**Victor Steinbrueck Park**  
**Certificate of Approval Amendment Request**  
**November 29, 2023**

**VICTOR STEINBRUECK PARK**  
**95% CD PRICING SET**

DESIGNED: LR/CG	DATE: 05/10/2019
DRAWN: JM/MS	SHEET: OF
CHECKED: DD	
ORDINANCE NO.:	<b>L102</b>
SPECIFICATION NO.:	
SCALE:

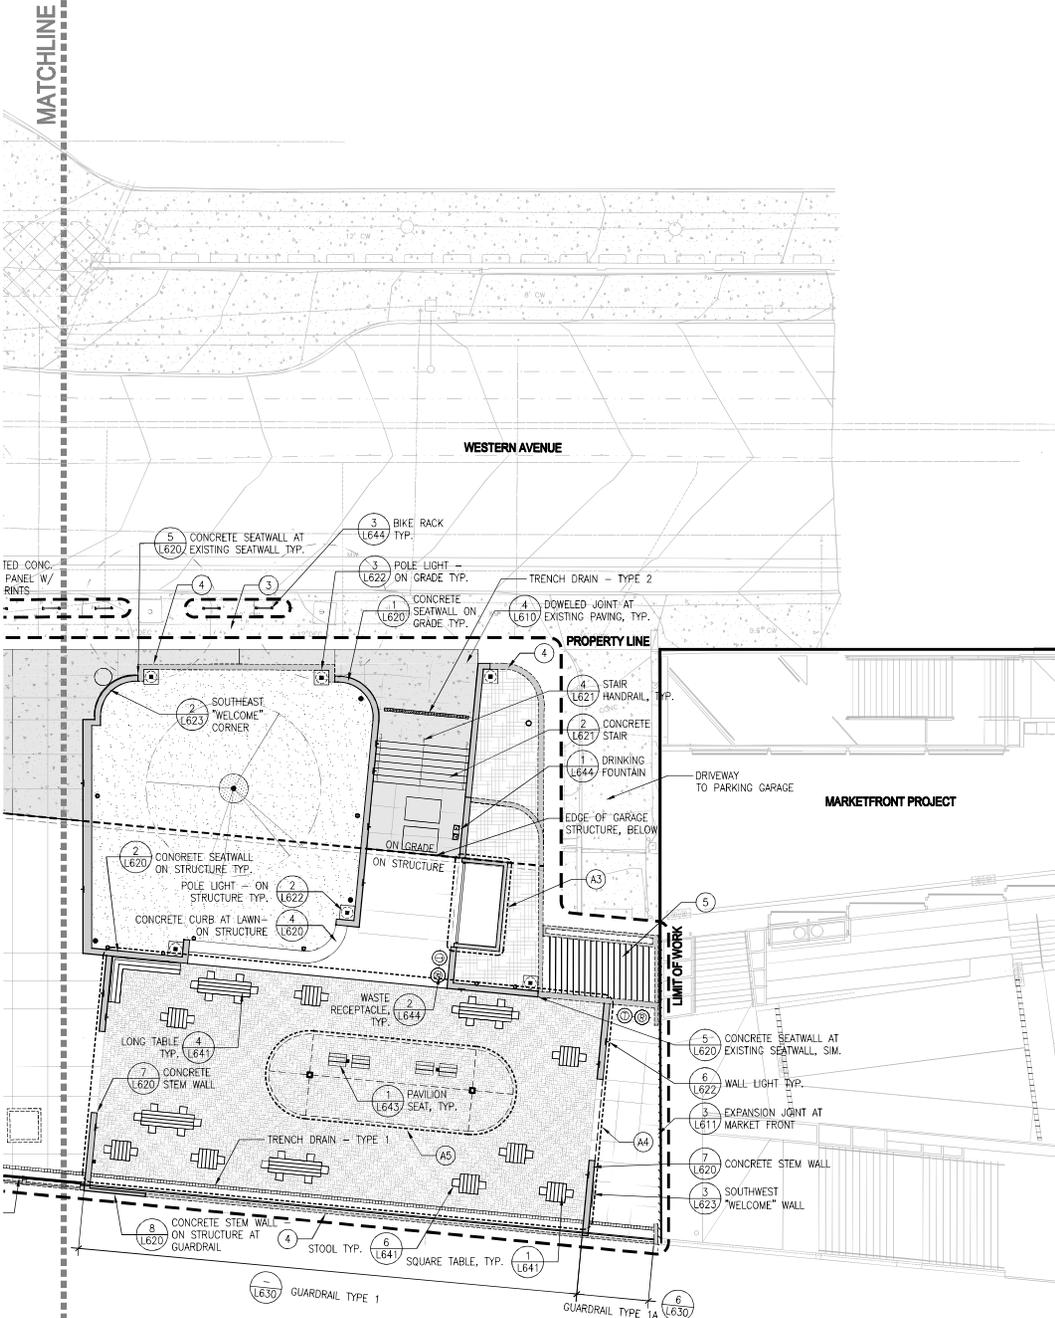
Construction is progressing and it is anticipated that the park could be reopened to the public in April 2024. SPR is requesting an amendment to the CoA to allow the permanent removal of the poles. SPR is proposing to install in their places two pieces fabricated/carved by members of the local Indigenous community that are representative of the local Tribes and local Tribal culture. These new pieces will be installed on the existing plinths using the existing attachment infrastructure. SPR is also requesting that the park be allowed to be reopened to the public while the new pieces are being carved/fabricated.

Previous location of totem poles, where proposed new features would be installed.
